Attorney General of New Mexico

6 January, 1998

Enclosed is a report by John Bredehoeft, Drilling with Air and Mud into WIPP—Revisited, discussing the implications for direct releases of recent DOE research and modeling concerning the spallings process. Main points are:

DRILLING with MUD and AIR into WIPP—REVISITED

Figure 1. Predicted amount of failed material during drilling penetration of the repository, estimated by GASOUT (Schatz, 1997)—with mud, run in the cylindrical mode. The tensile strength of the waste is 10 psi. The lines are best fits through the data; repository pressure is indicated in MPa.

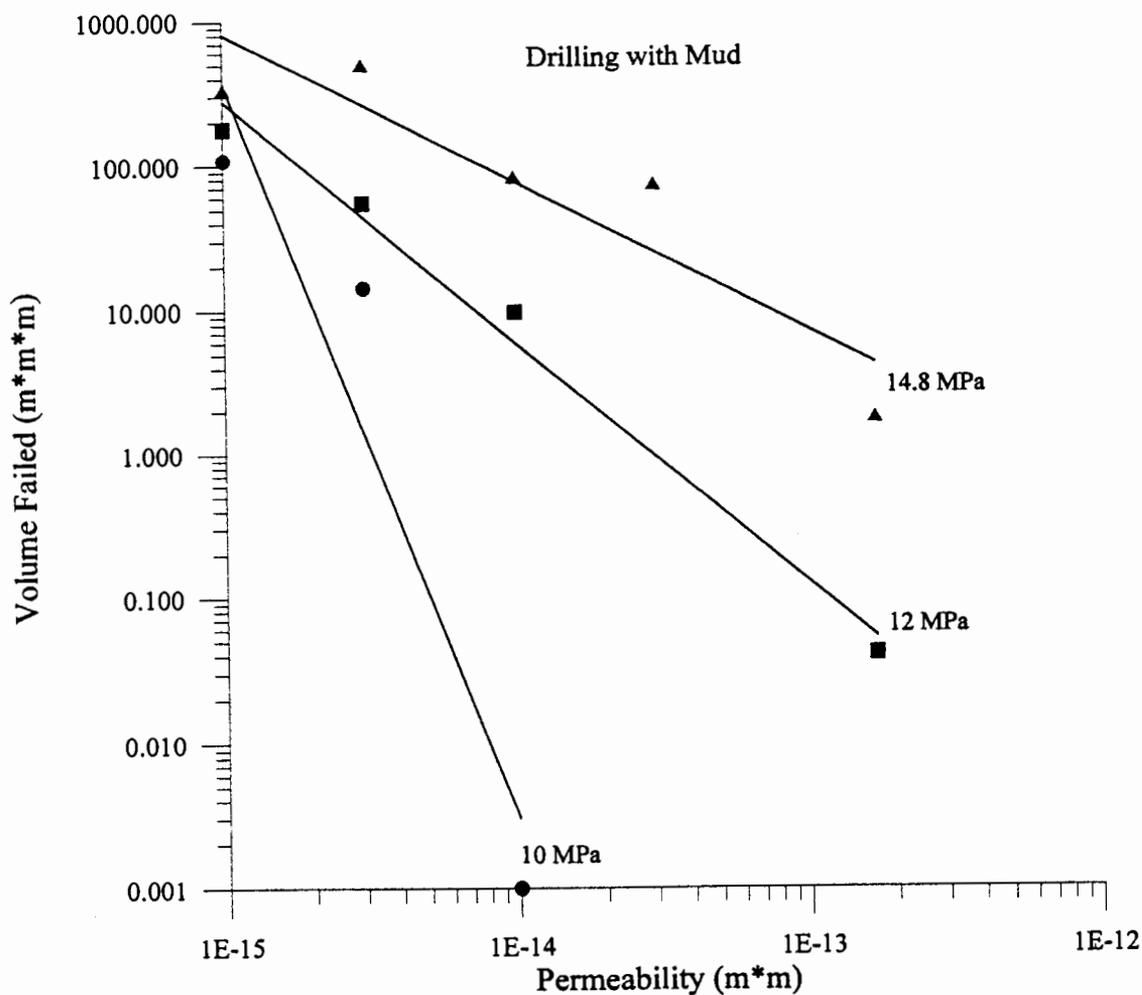
The Peer Review Panel recognized that the volume of failed material increases with lower permeability, even when there is mud in the hole—as shown by Figure 1.

Curiously, Hansen et al. (1997, p. 3-35) explored the effect of permeability on spalling in the case of mud, but did not report results for the failed volume of material other than at a waste permeability of $1.7 \times 10^{-13} \text{ m}^2$. At permeabilities of the order of 10^{-14} m^2 with high repository pressure (12 to 14.8 MPa), GASOUT, with mud in the borehole, predicts failed volumes ranging from approximately 10 to 1000 cubic meters (at a tensile strength of 10 psi)—see Figure 1. EEG (1997) in its comments to EPA came to similar conclusions regarding the volumes of failed waste material that would accompany a drilling intrusion.

Figure 3. Failed volumes during a drilling intrusion with air predicted by GASOUT—in the cylindrical mode; waste tensile strength is 10 psi. The lines are best fit lines through the data; the repository pressure is indicated in MPa.

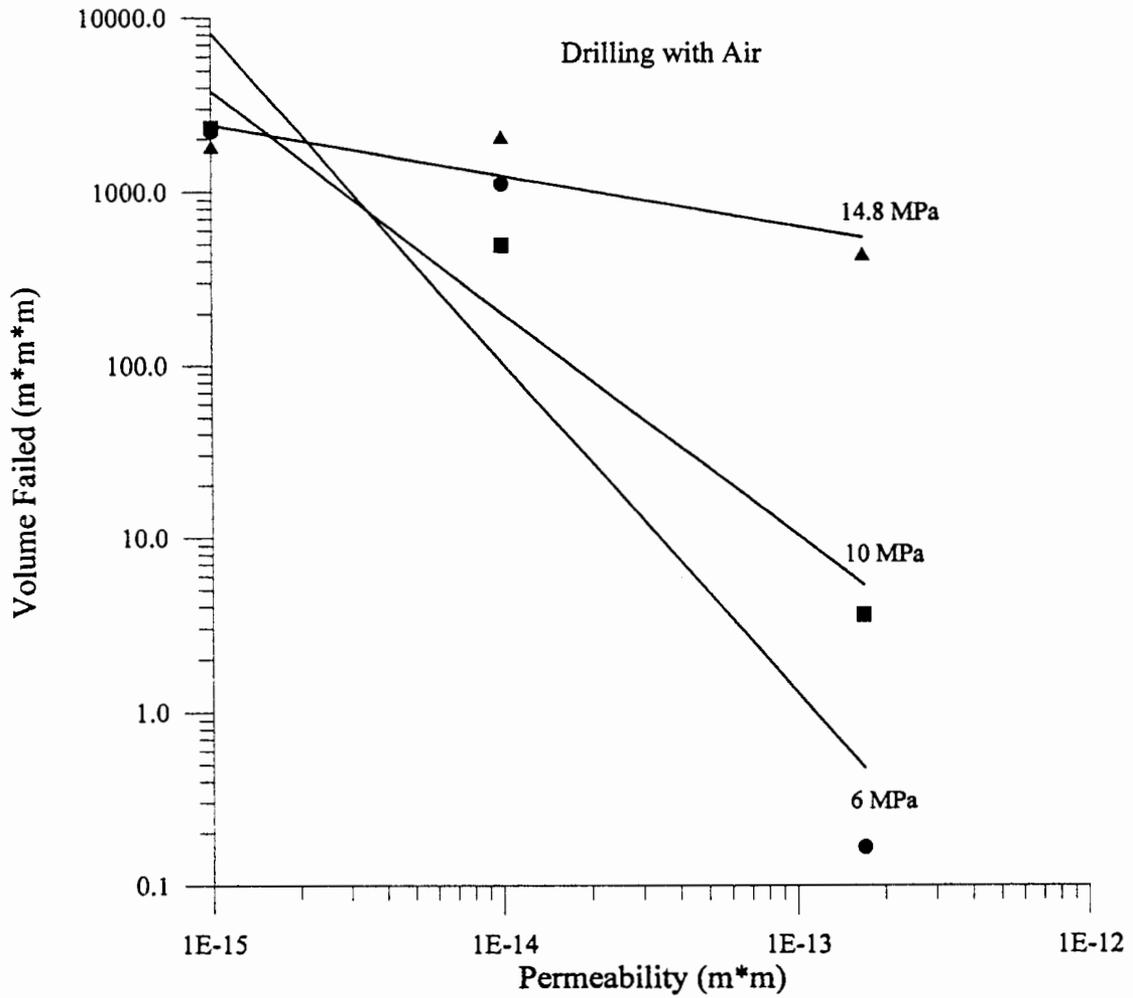
Our use of GASOUT is summarized in Figure 3; it shows the volume of failed material in the air drilling scenario. The volumes are large; however, they are only a factor of 2 to 4 times larger than with mud—see Figure 1. GASOUT also suggests that the failure of material occurs quickly—in a matter of a few seconds. In making the calculations for Figure 3 we restricted the simulation of the blowout to the first 5 seconds after the repository is penetrated.

Figure 4. Failed volumes for an air drilling intrusion at varying repository pressure and tensile strength for a constant permeability of $1.7 \times 10^{-13} \text{ m}^2$, predicted by GASOUT.

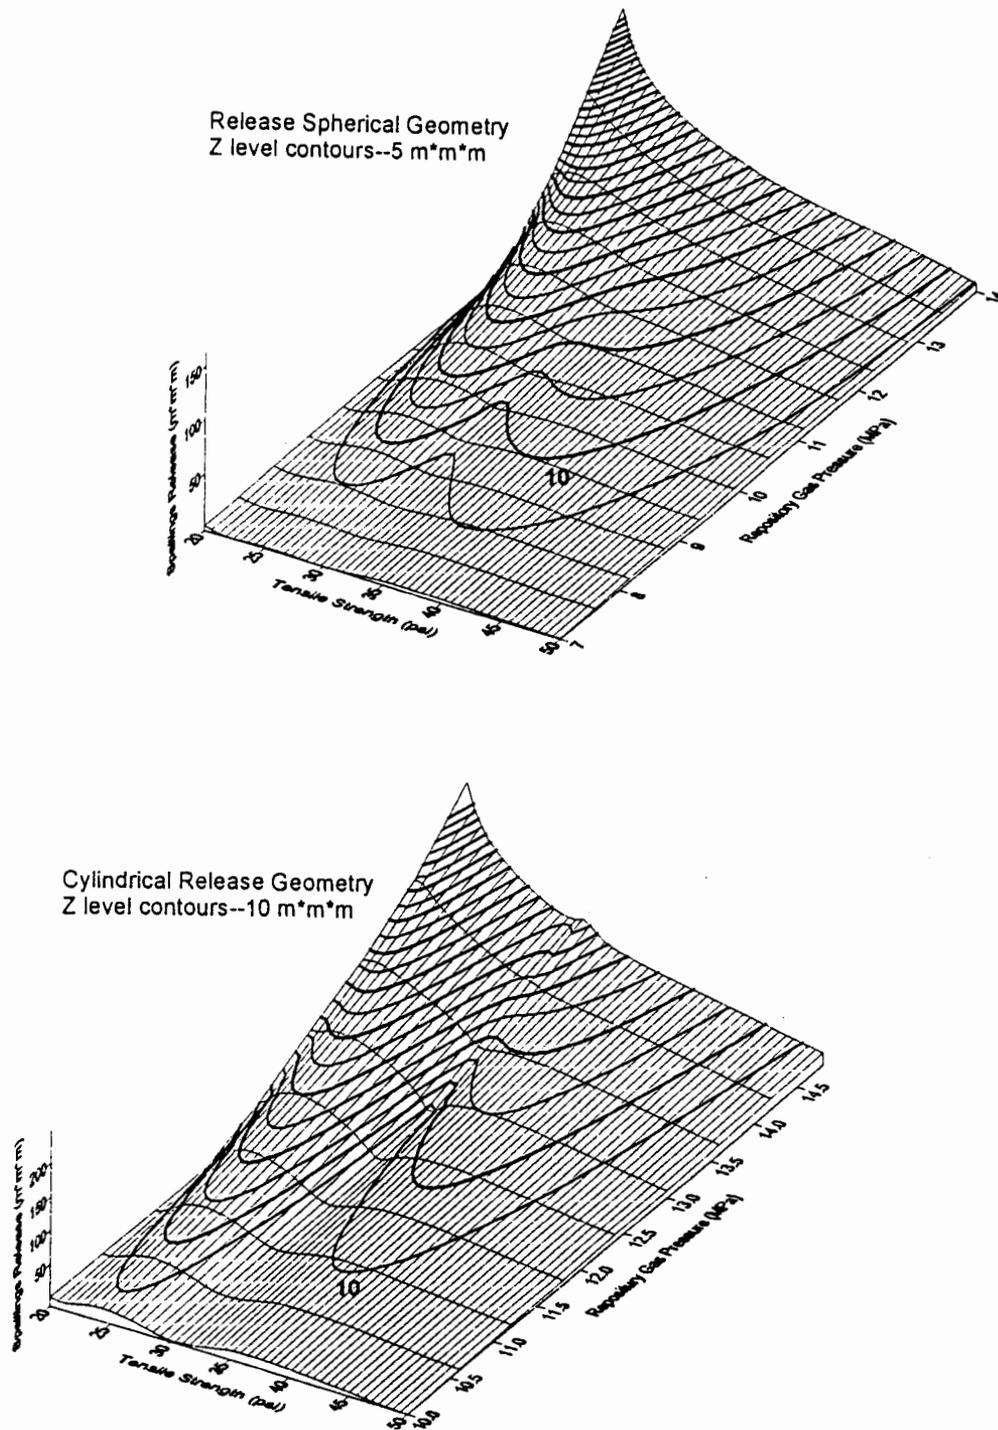
We also explored the effect on the failed volume of the tensile strength of the waste using GASOUT. Figure 4 shows the volume of waste failed during an air drilling intrusion for different repository pressures and tensile strength. In this instance the permeability is constant at 1.7×10^{-13} m².

Figure 5. scenario.

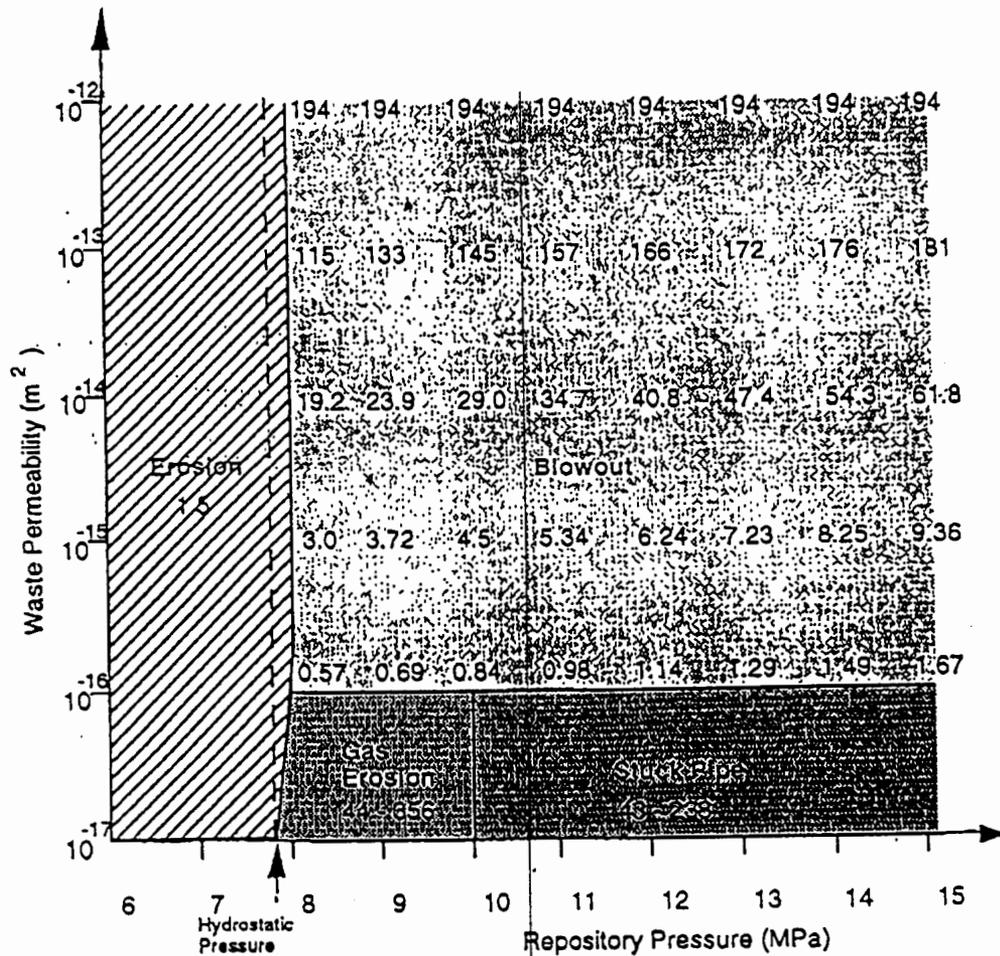
In the earlier analysis Berglund (1994) suggested that stuck pipe was only a problem when the waste permeability was less than 10^{-16} m^2 . Figure 5 is taken from Berglund (1994). Since the waste permeability was assumed in the CCA to be $1.7 \times 10^{-13} \text{ m}^2$ stuck pipe was not regarded as a problem.

However, as suggested above, the more recent model suggests very large volumes of failed material at low permeabilities, permeabilities above 10^{-16} but in the range 10^{-14} to 10^{-15} m^2 where a blowout does not occur. Given volumes of failed waste as large as indicated above, it is likely that the circulating drilling fluid, either air or mud, cannot cope with these volumes, and stuck pipe is likely.

Figure 6. Maximum size of particles (diameter) expelled as a function of time (Figure 4-22, Hansen et al., 1997).

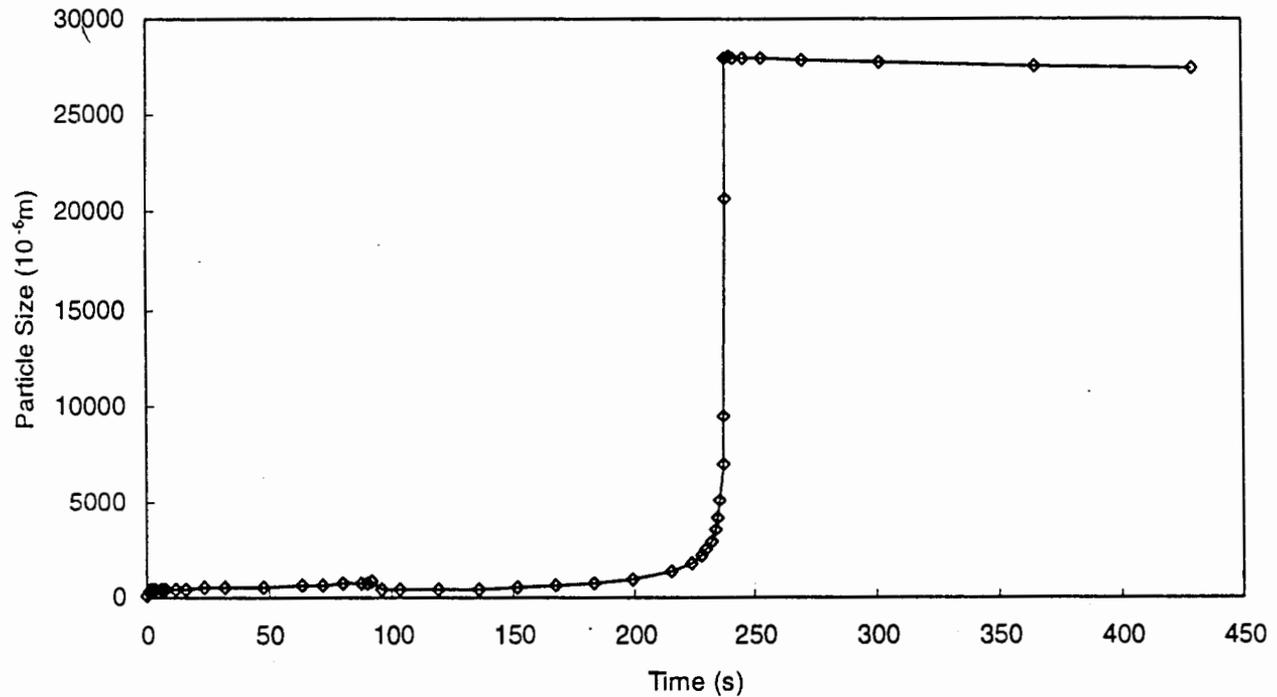
The discrepancy between the two models is marked; the results are approximately two orders of magnitude, or more, different. Clearly both models cannot be appropriate for this analysis. The two investigations by DOE and EPA are not coherent and contradict one another (EPA, 1997a, EPA, 1997b, Hansen et. al., 1997).

In both cases the models omit the process of the drilling and actions of the driller. They do not full describe the entire drilling process. These are critical omissions as we show above.
